Final Initial Study/Mitigated Negative Declaration

LS Power Grid California Manning 500/230 Kilovolt Substation Project

June 2025

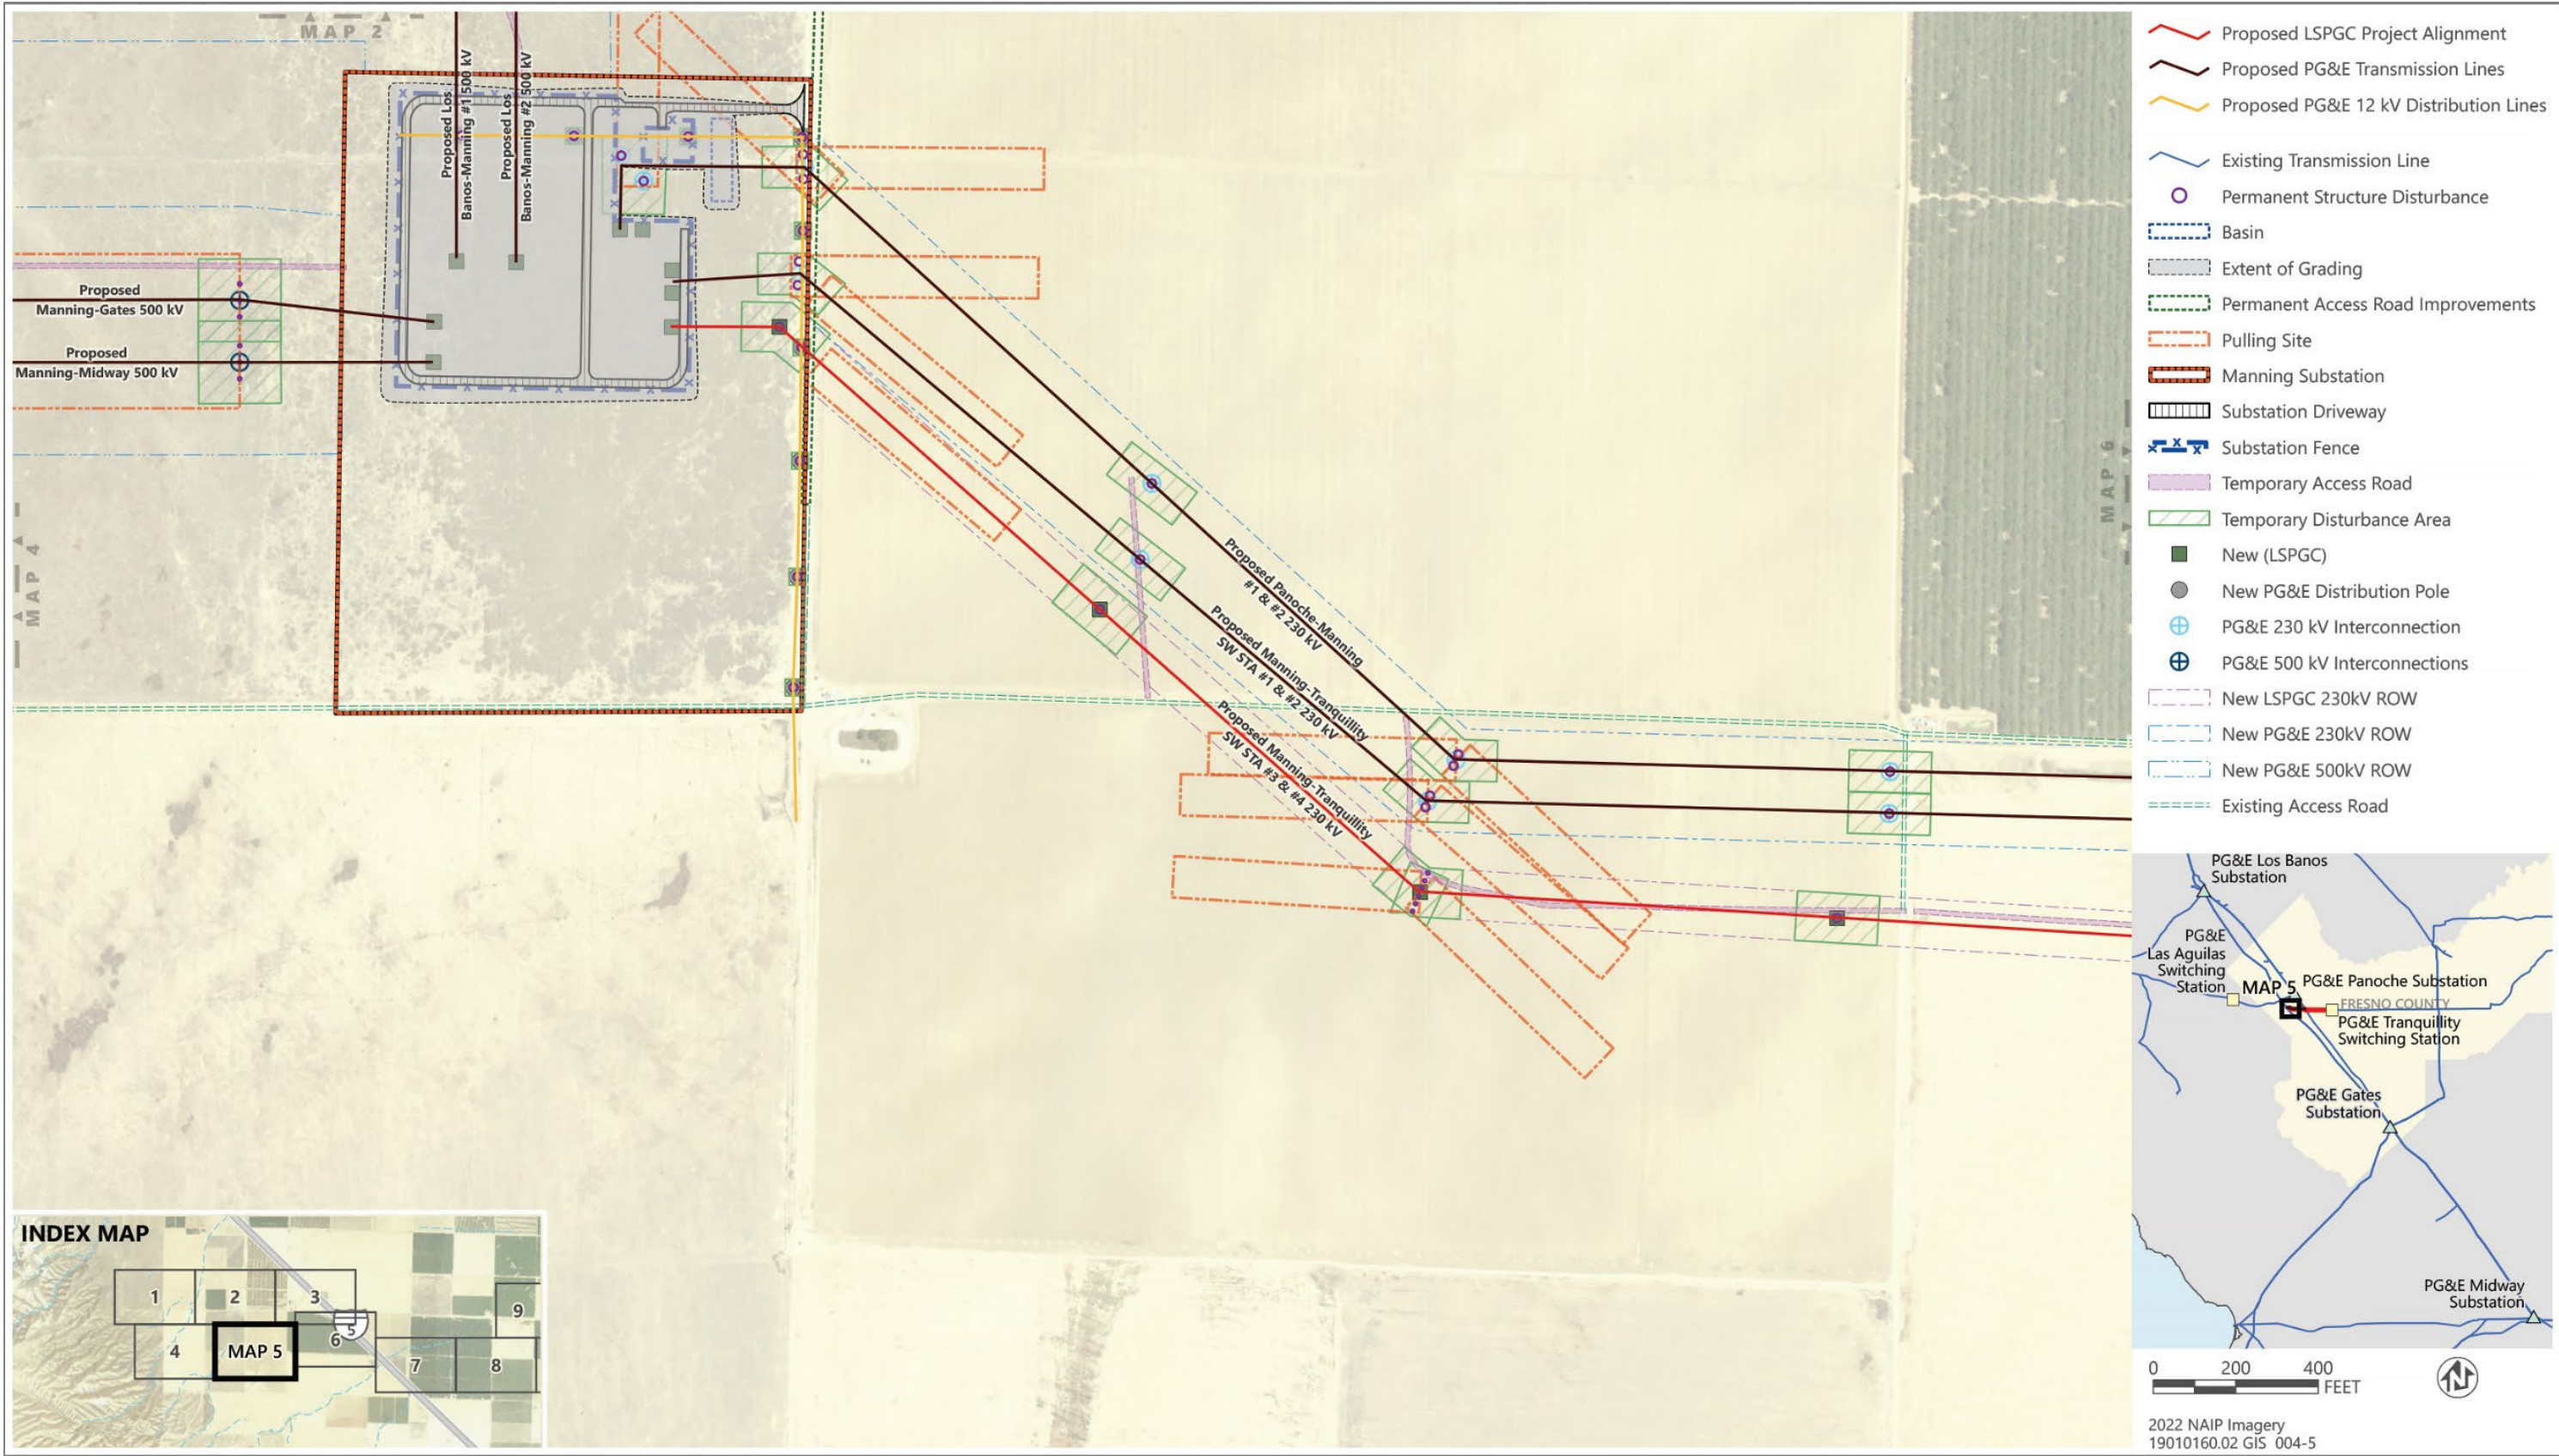
In response to Comment O1-16, revisions have been made to Project Element Map 5 of 23 on page A-5 of the Appendix A to Appendix 1:

Project Element Map 6 of 23

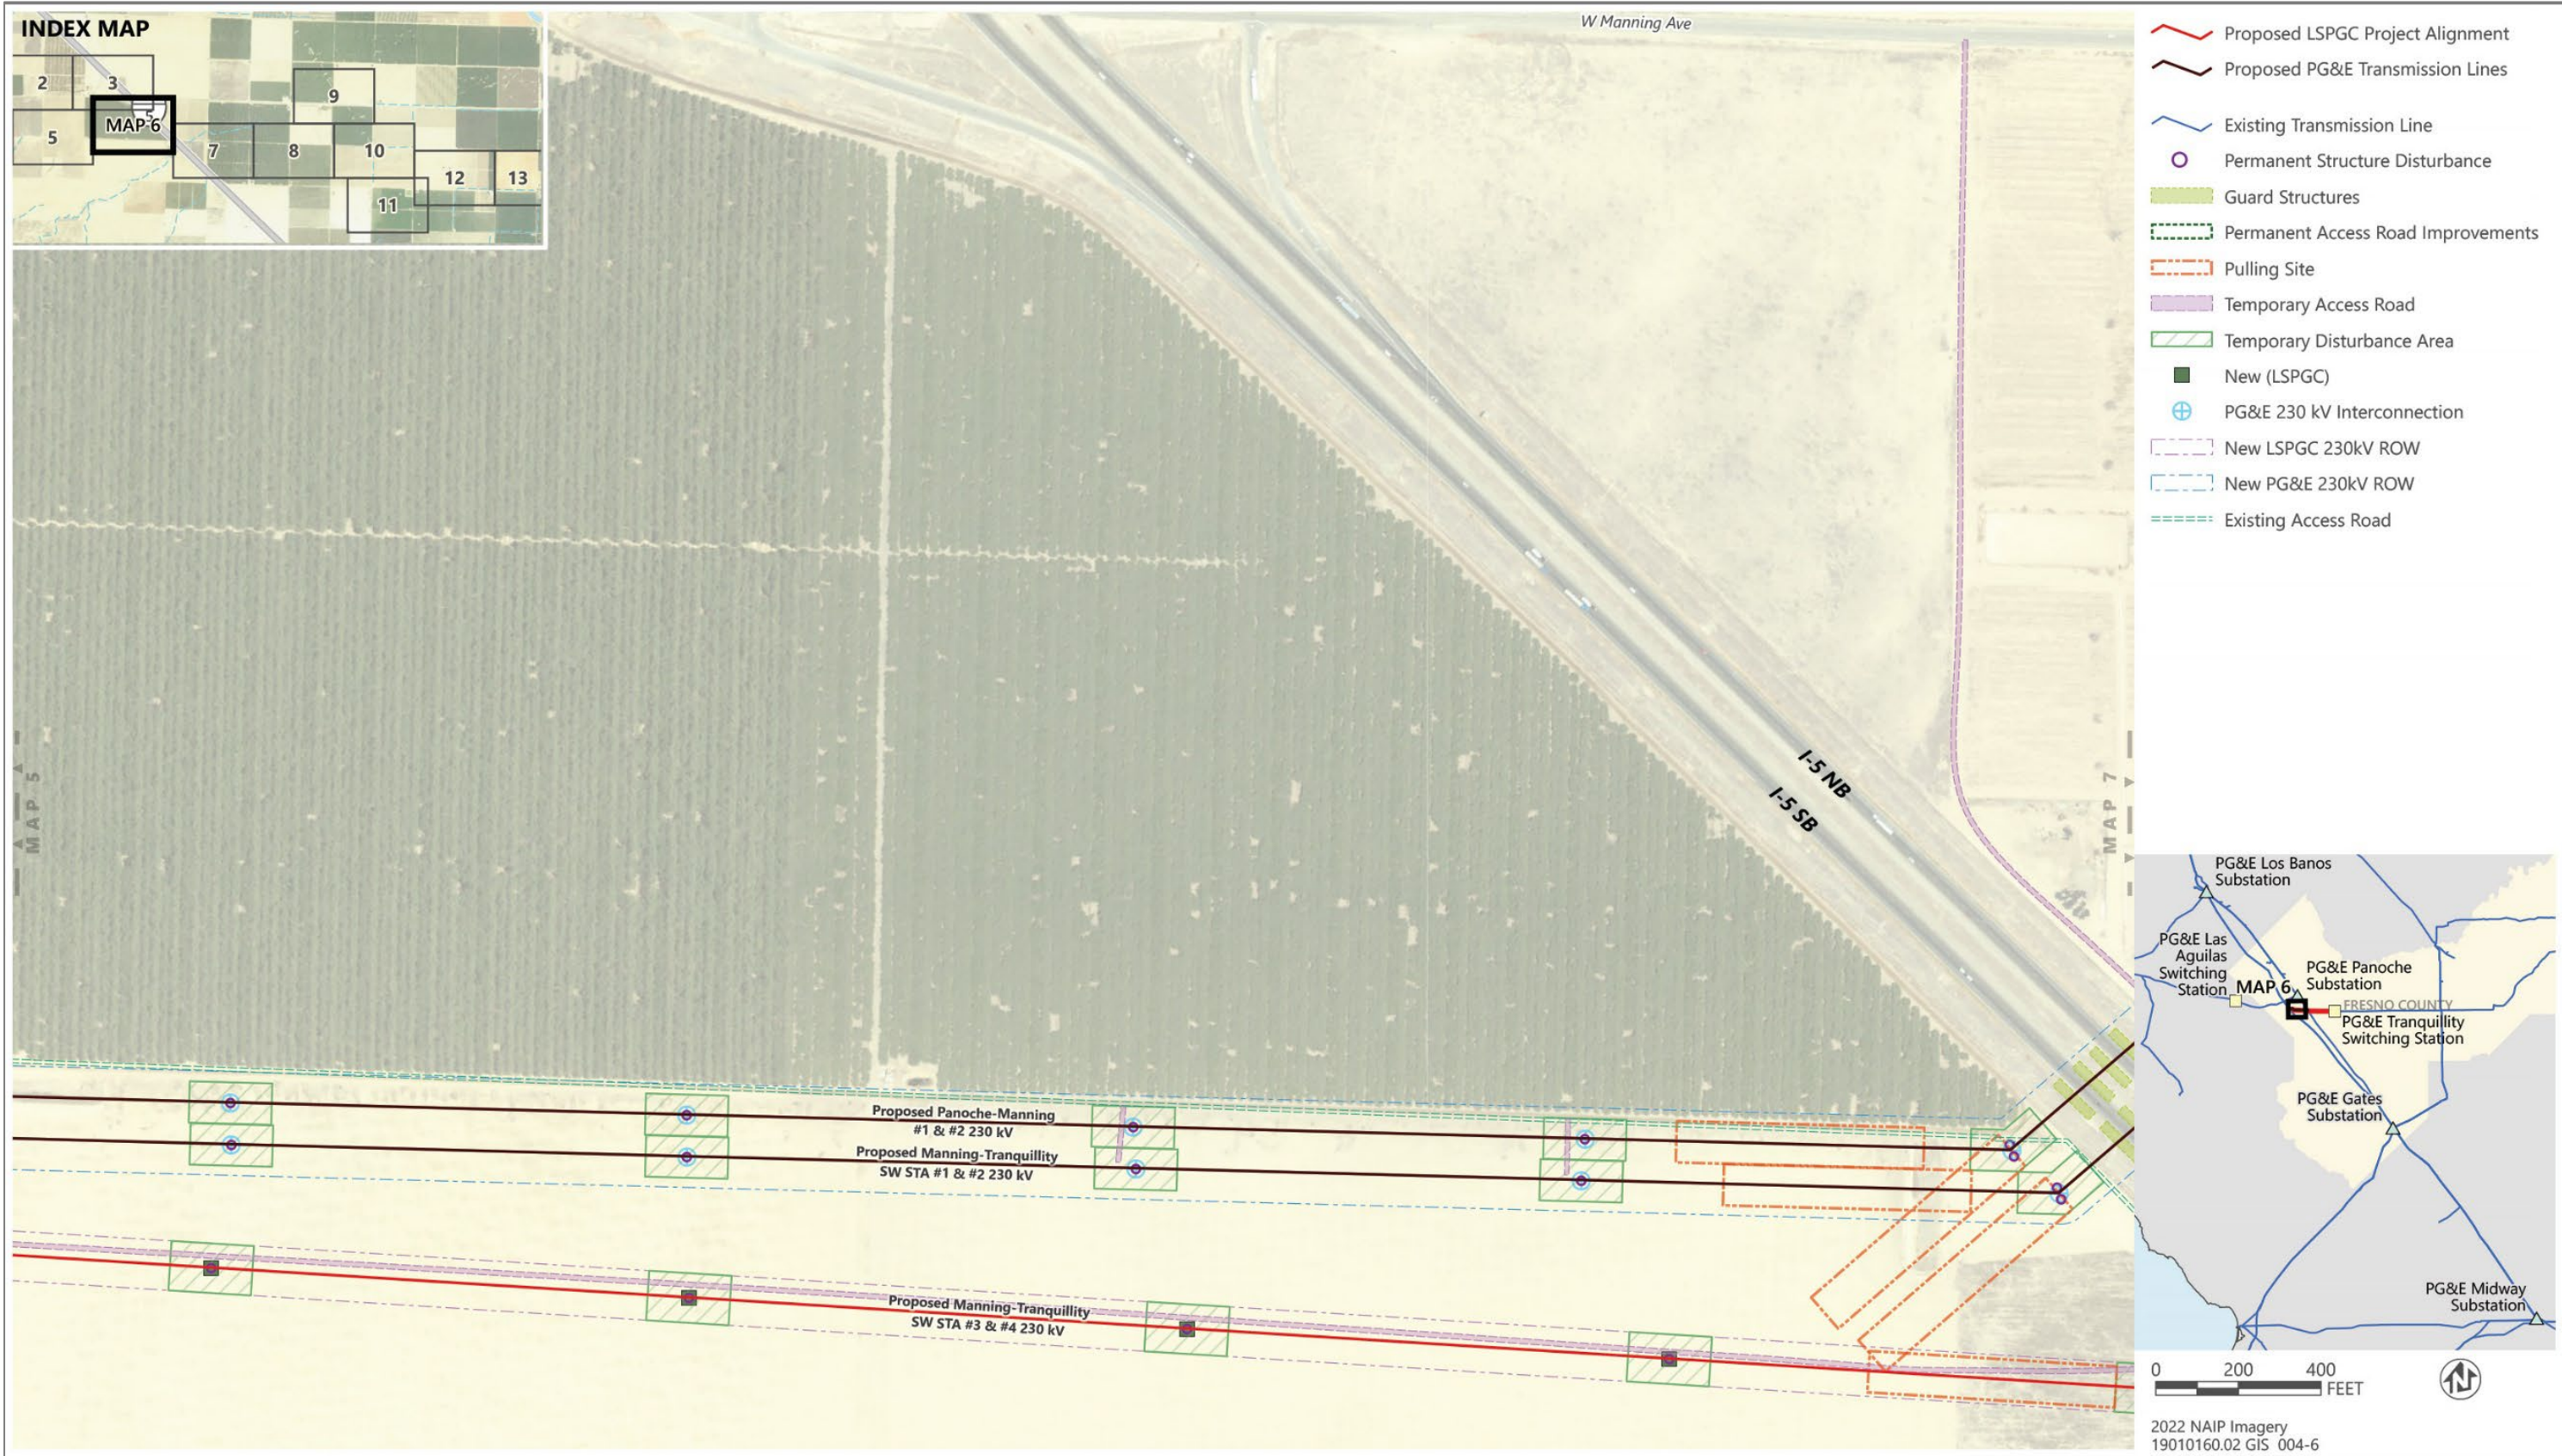
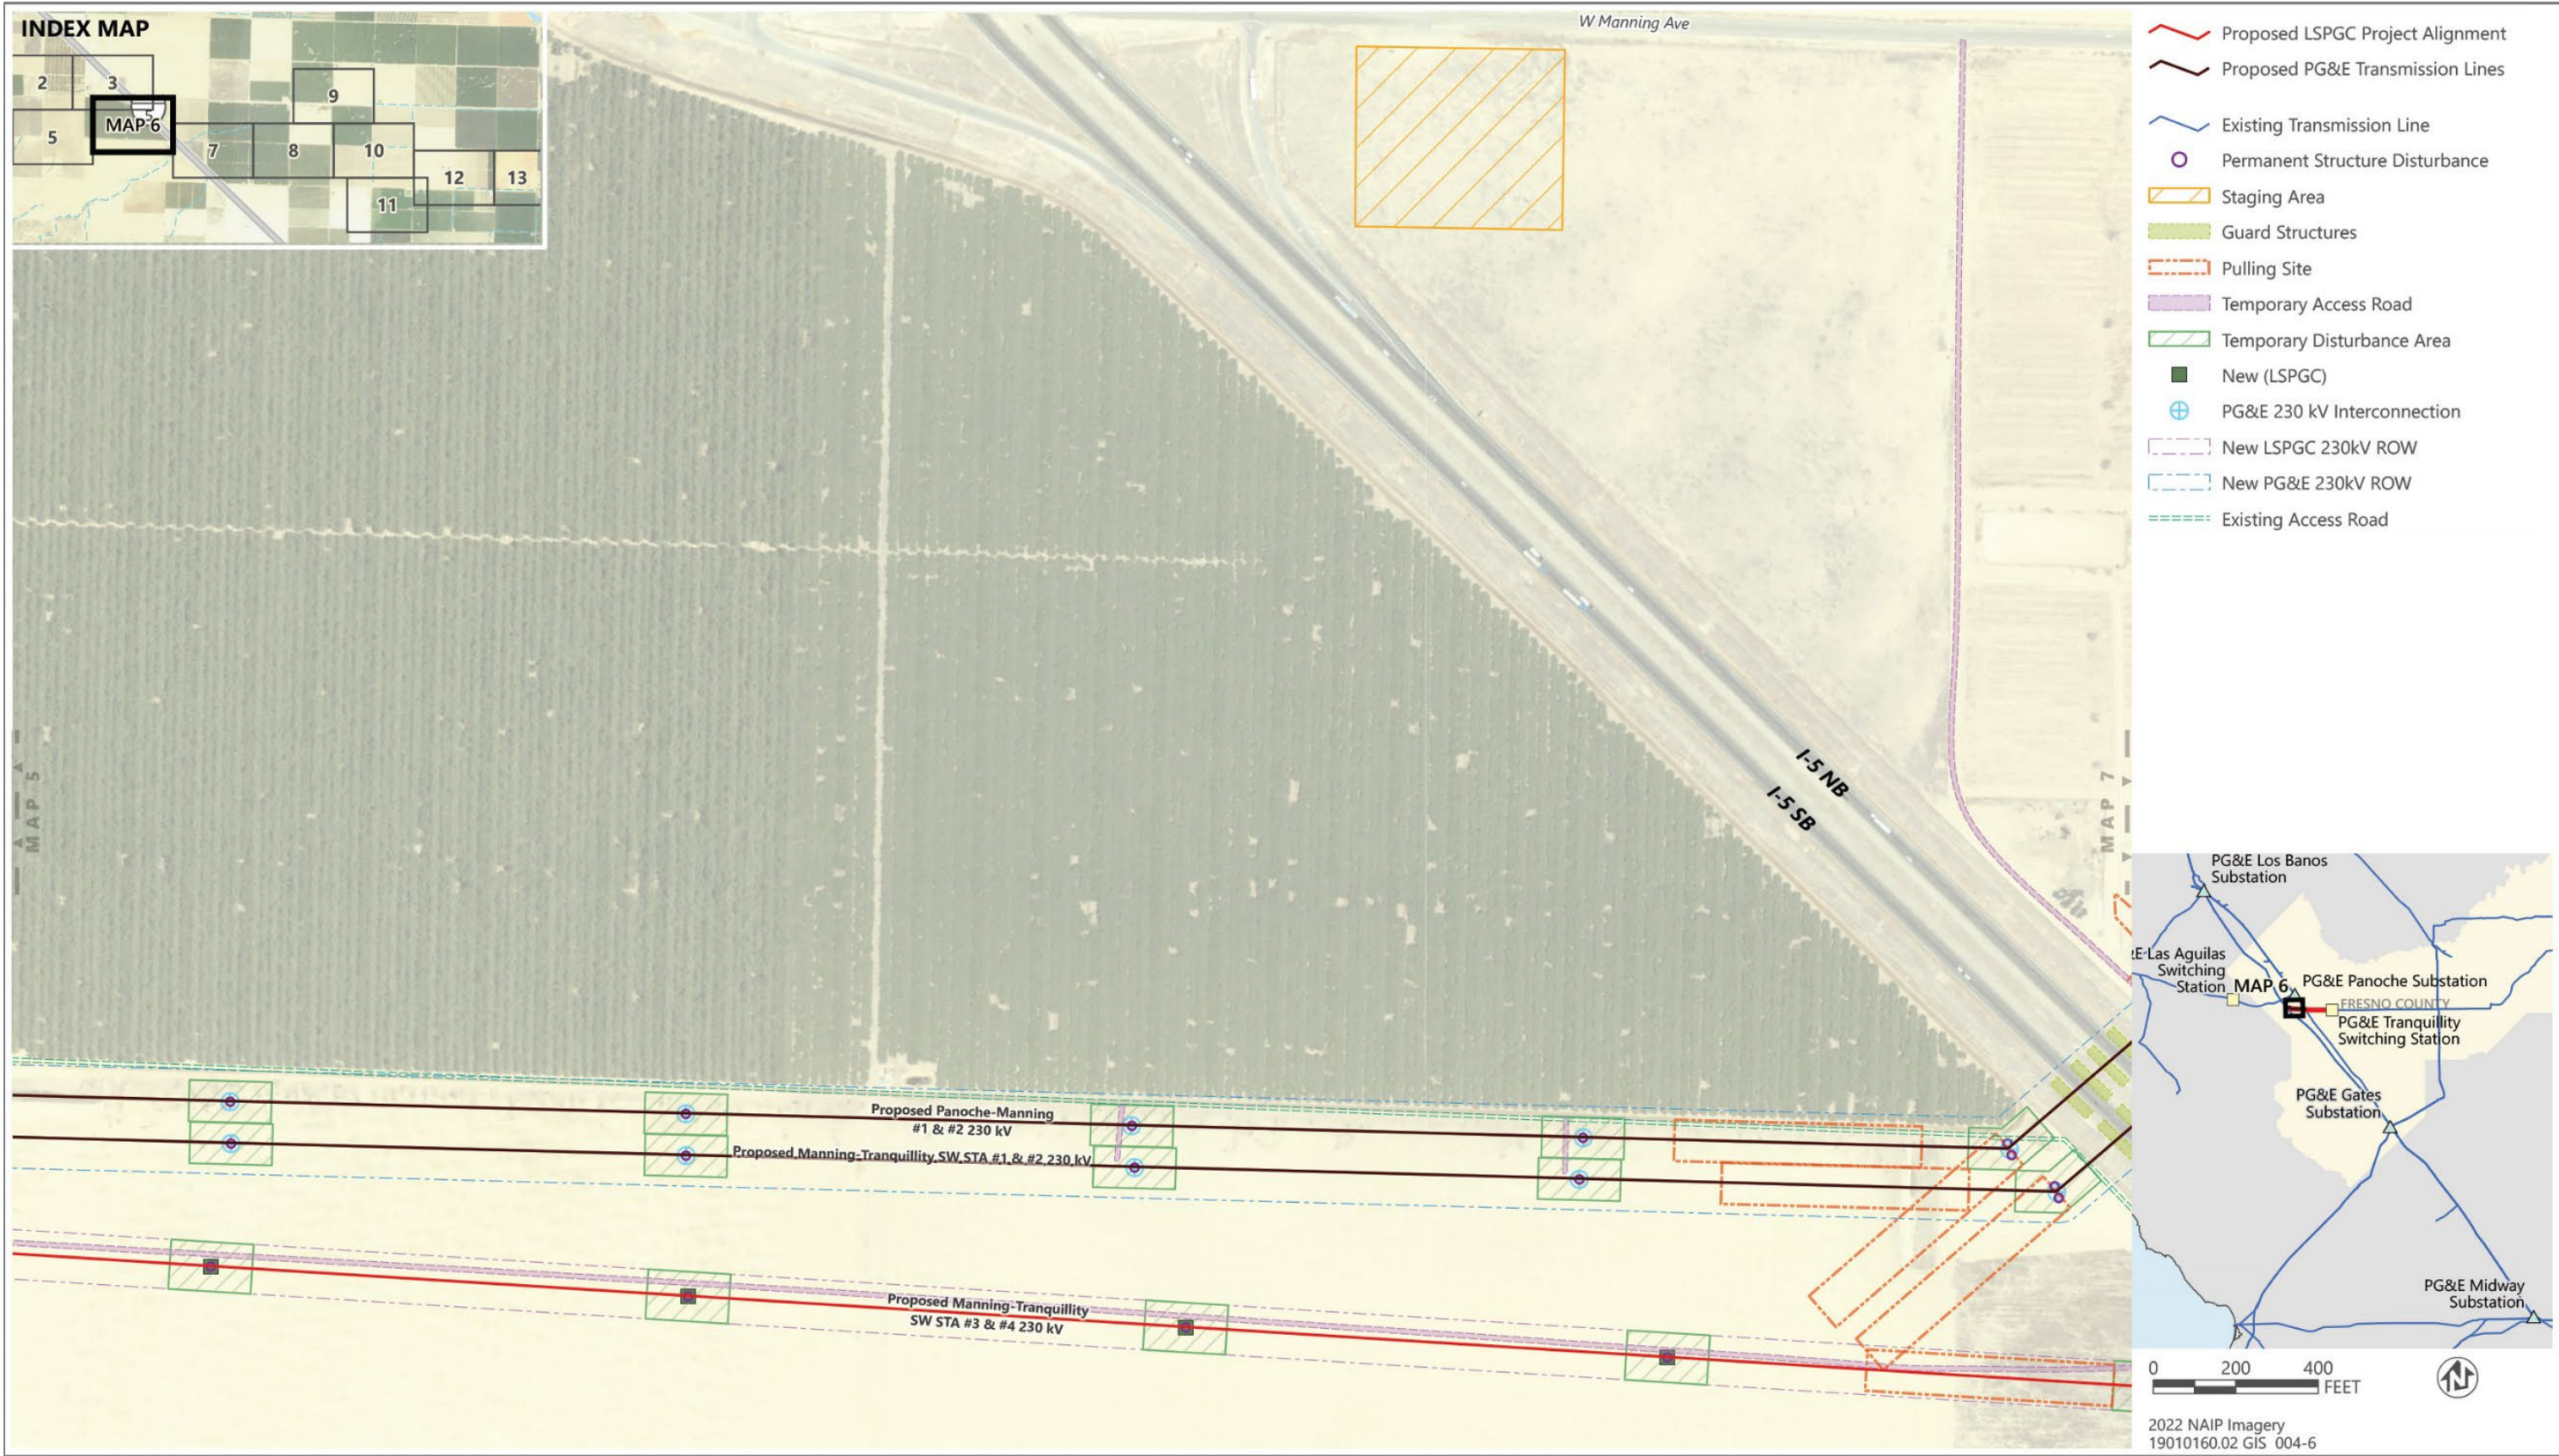
In response to Comment O1-16, revisions have been made to Project Element Map 6 of 23 on page A-6 of the Appendix A to Appendix 1:
